Manual Page Number	Revision

Manual Page Number	Revision
80–81	Maintenance, Electrical Assembly: The electrical assembly supplied on current machines has changed. The current system control conforms to ISO 13849, Performance Level d. Components are shown in the parts section of this addendum. Inspection information for the current assembly is below. **Inspection, Current Electrical Assemblies** **Safety monitor:** the function and operation of the monitor are described in the entry for page 15. When checking the terminal screws for tightness, torque to 5 inch-pounds or 0.56 newton meters. **Mini Circuit Breakers (MCB) and Fuses:** the electrical enclosure is supplied with fuses or mini circuit breakers. Mini circuit breakers (MCBs) are used with power supplies at 240 volts and lower. At 380 to 480 volts, a Wye power supply is necessary to use MCBs (Wye is the most common power supply worldwide). Delta supplies at 380-460 volts use fuses. Fuses are also used for both Delta and Wye 575 volt supplies. MCBs, when tripped, must be switched off and then on again to reset. If fuses fail or MCBs trip frequently, investigate the cause.

Locations of Sensor Leads on the Safety Monitor					
Switch Number	**1**	**2**	**3**	**4** (Grease Spindle Only)	**6** (Oil Mist Spindle Only)
Guard	Belt Guard	Upper Cutting Enclosure	Feed Hopper	Rear Guard	Oil Pressure and Level Switches
Switch Input	IN1	IN2	IN3	IN4	IN6

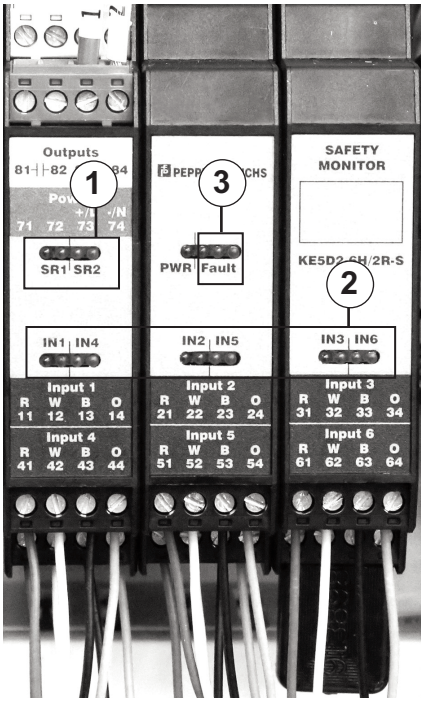
Safety, Safety Switch System Test: The electrical enclosure as currently supplied uses a safety monitor instead of an amplifier. The safety system test procedure is the same; refer to the entry on the previous page for information on the safety monitor. Perform the safety switch test **daily**.

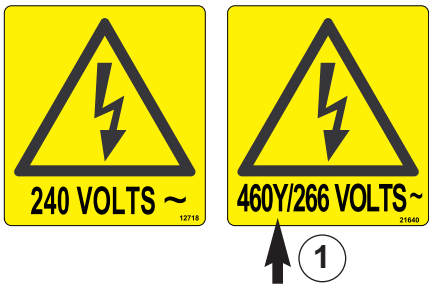
Installation – Electrical Power:
add to Step 1: A machine with a hazard alert label with a ***"Y" (1)*** in the voltage designation contains mini circuit breakers (MCBs) and requires a Wye power supply. To check for a Wye power supply, first calculate the voltage to ground by multiplying the supply voltage by .577. Next, measure the voltage at each phase to ground and compare to the calculated value.

For example, at 400 volts, a Wye supply will measure approximately 230 volts from one phase to ground (400 x .577). One phase may read 0 volts, which is acceptable. A Delta supply at 400 volts will measure 400 volts from one phase to ground. If the machine is supplied with mini circuit breakers or the label designates a Wye power supply, and the voltage from one phase to ground exceeds 277 volts, contact an Urschel service representative.
